CONNECTICUT YANKEE ATOMIC POWER COMPANY

Haddam Neck Plant  
Systematic Evaluation Program Integrated Assessment

Attachment 1

Integrated Assessment Supplement

CONNECTICUT YANKEE  
PRESENT DC BUS / VITAL AC BUS ARRANGEMENT

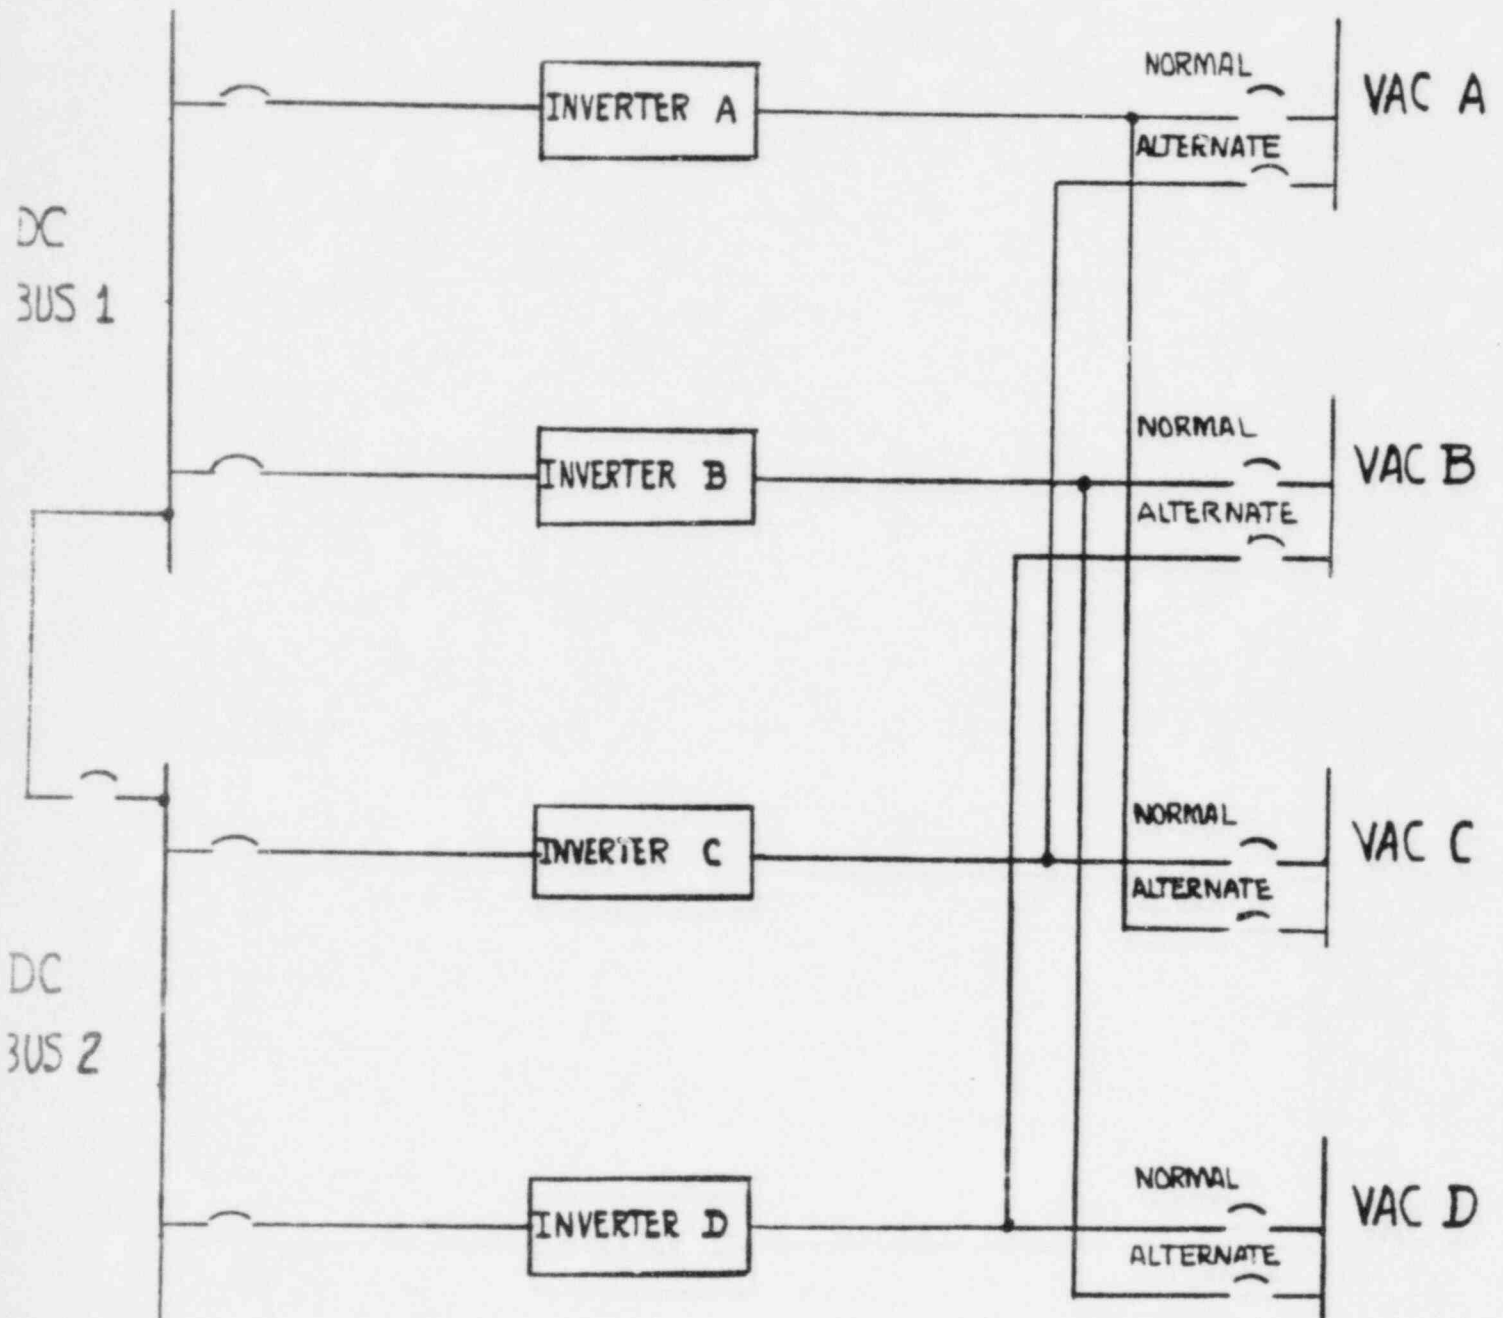
The Haddam Neck onsite standby AC and DC power systems do not comply with current licensing criteria. In each case, a manual breaker exists which allows paralleling of the two power divisions; no interlocks or procedures prevent this. Additionally, the DC power system design permits all four inverters to be supplied from a single battery.

For the manual tie breaker between DC buses 1 and 2, CYAPCO will provide a locking device and administrative control. Since by design this breaker cannot physically be removed from its compartment, CYAPCO concludes that these controls are adequate.

All four inverters can be powered from one battery only by tying the two DC buses together and removing one battery from service. This not only powers all four inverters from one battery but also powers the entire DC system, both divisions, from one battery. As discussed above, this will be administratively prevented during power operation.

Each of the four inverters supplies a separate vital AC bus. Each of the vital buses has an alternate source of power which can be switched into service manually. The alternate source breaker for each vital bus is interlocked with the normal source breaker so that both cannot be closed at the same time. Presently, however, the alternate source of power for each vital bus is supplied by an inverter from the redundant division. Thus, if one vital bus is fed from its alternate source, three vital buses would be receiving power through two inverters from one battery. CYAPCO intends to modify the existing alternate feeds to the vital buses so that the alternate source for each vital bus is taken from the other inverter in the same division. Therefore, it will not be possible to power three vital buses from one battery. Sketches of the existing and proposed arrangements are attached. CYAPCO intends to complete these modifications in conjunction with the modifications planned as a result of the Appendix R Fire Protection review.
